Product Change Notification

Product Change Notification: P-22-023437

Mezlok connectors

Example of drawing change

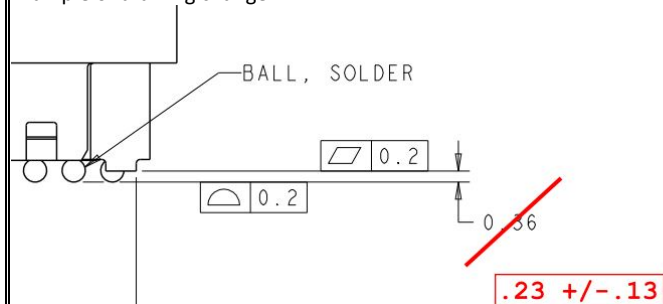
Changing the .36 dimension on the customer drawings to .23 +/- .13. This dimension depicts the distance between the tip of the solder balls and the standoffs on the bottom of the connector. The old dimension did not take into account the deformation of the solder balls during their attachment to the connector contacts. We have conducted a soldering test on specimens on the lower end of this new tolerance range and found that the parts adhere acceptably to the PCB solder pads. We have also begun 100% screening for this dimension, in addition to the coplanarity checks we already perform. No change has been made to the product.
